Service Bulletin

LINE SET SIZE MISPRINT IN INSTALLATION MANUAL

Bulletin No.: 004
Issue Date: August 7, 2025
Models: AJAN24HP230V1CH, AFEB24HP230V2CH, AMAR24HP230V1CH

Left: pipe size table as printed in the manual (incorrect). Right: corrected table.

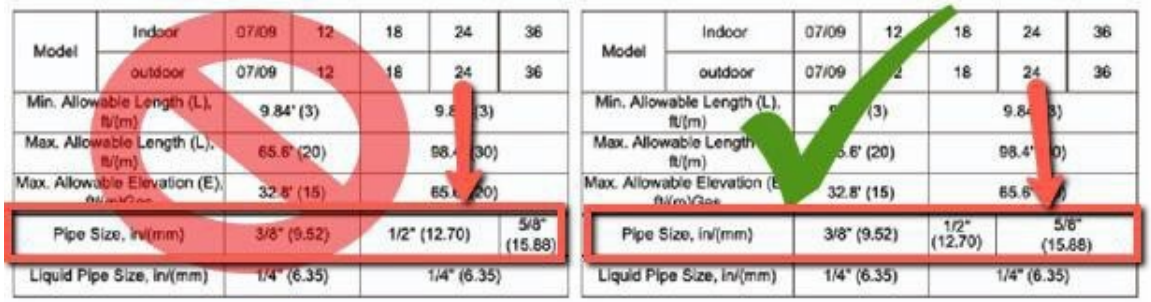
The installation manual for the models listed above contains a misprint in the required refrigerant line set size. For these 24K models, the manual lists the suction (gas) line as 1/2”. The correct size is 5/8”.

Line	As Printed (Incorrect)	Correct Size
Liquid line	1/4” (6.35 mm)	**1/4” (6.35 mm)**
Suction (gas) line	1/2” (12.70 mm)	**5/8” (15.88 mm)**

- Disregard the incorrect line set size printed in the manual.
- Use a 1/4” liquid / 5/8” suction line set when installing these units.
- Communicate this correction to all relevant installation and service personnel.
